Access Compliance Report

Public Rights-of-Way

(Curb Ramps)

Intersection ID: 47850	Main Street: LAGO_VISTA_CT	Cross Street: SERAPE_RD	Location: SW
ADA ID: 519E8D46EEA4	Ramp Type: PerpDiag	Initial Pass/Fail: Fail	Overall Compliance: No
Severity Score: 21.25			
Codes/Mitigation Info/Possible Solution		Field Measurements/Component Compliance

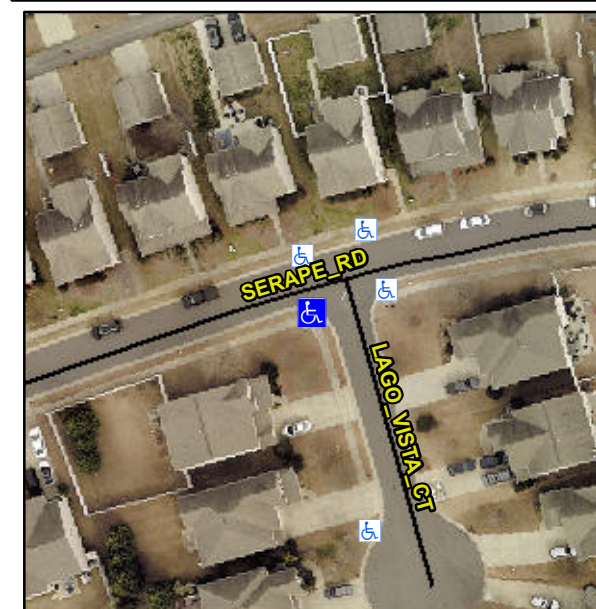
Not Found, R304.5.1, R304.2.2

Compliance	Description	Data	Compliance	Description	Data
N/A	Ramp Length (in)	48.0	No	Ramp Slope (%)	8.9
No	Ramp Width (in)	44.0	Yes	Ramp XSlope (%)	1.5
N/A	Flare Type LT	N/A	N/A	Flare Type RT	N/A
N/A	Flare Slope LT (%)	N/A	N/A	Flare Slope RT (%)	N/A
N/A	Flare Traversable LT?	N/A	N/A	Flare Traversable RT?	N/A
N/A	Landing Length (in)	N/A	N/A	DWS Provided?	N/A
N/A	Landing Width (in)	N/A	N/A	DWS Contrast?	N/A
N/A	Landing Slope (%)	N/A	N/A	DWS Length (in)	N/A
N/A	Landing X Slope (%)	N/A	N/A	DWS Full Width?	N/A
N/A	Landing Curb? (Y/N)	N/A	N/A	DWS Offset (in)	N/A
N/A	Shared Landing?	N/A			
N/A	Gutter Ponding?	N/A	N/A	Gutter Slope (%)	N/A
N/A	Gutter Lip Ht (in)	N/A	N/A	Gutter X Slope (%)	N/A
N/A	Painted X Walk1?	No	N/A	Painted X Walk2?	No
	X Walk 1 Direction	To E		X Walk 2 Direction	To N
N/A	X Walk 1 Width (in)	N/A	N/A	X Walk 2 Width (in)	N/A
	X Walk 1 Slope (%)	0.8		X Walk 2 Slope (%)	0.8
	X Walk 1 X Slope (%)	2.1		X Walk 2 X Slope (%)	0.9

Remove & Replace Curb Ramp With Two New Directional Ramps or Equivalent.
